**REPORT ON  
ADDENDUM TO IRM-8 WORK PLAN  
UPDATED IRM-8 COVER SYSTEM CONSTRUCTION  
PHILIPS LIGHTING COMPANY BATH FACILITY  
BATH, NEW YORK**

File No. 127981-030  
Revised December 2023

Subject: Addendum to IRM-8 Work Plan  
Updated IRM-8 Cover System Construction  
Philips Lighting Company Bath Facility  
7265 State Route 54  
Bath, New York  
BCP Site #C851044

**FIGURE 1**

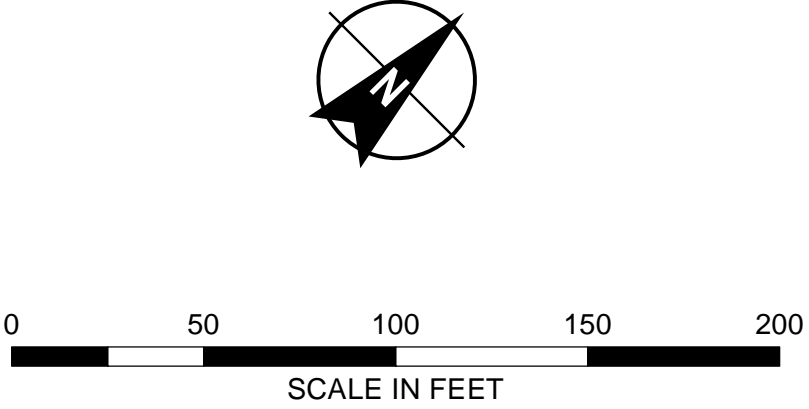
The area where the 7,300 cy of sub-base material will be removed includes asphalt-covered areas in the employee and office parking lots and asphalt-covered roadways along the west side of Buildings 2, 3/4, 5, and the south and west sides of the former Chemical Intermediates Building. Figure 1 shows the asphalt areas that are planned to be milled and removed as part of the ongoing demolition activities.

Samples of the sub-base material will be collected from test pits using a small hydraulic excavator and the test pits are expected to be extended to approximately 1 to 2 feet deep, depending on the thickness of the asphalt and sub-base materials beneath the paved surfaces. The test pit and sampling locations will be spatially distributed within the asphalt-covered areas. The proposed sampling locations are shown in Figure 1 and the sampling analysis plan is included as Table 1.

The excavated material would be placed on plastic sheeting immediately next to the test pit and the samples would be collected directly from the excavated material. For the collection of the composite samples, sub-base material collected from between three and five excavations (as shown on Figure 1) would be collected from the excavated material at each test pit and then combined in a dedicated stainless-steel mixing container, blended to develop a homogenous sample, then the composite sample would be transferred to the appropriate sampling containers.
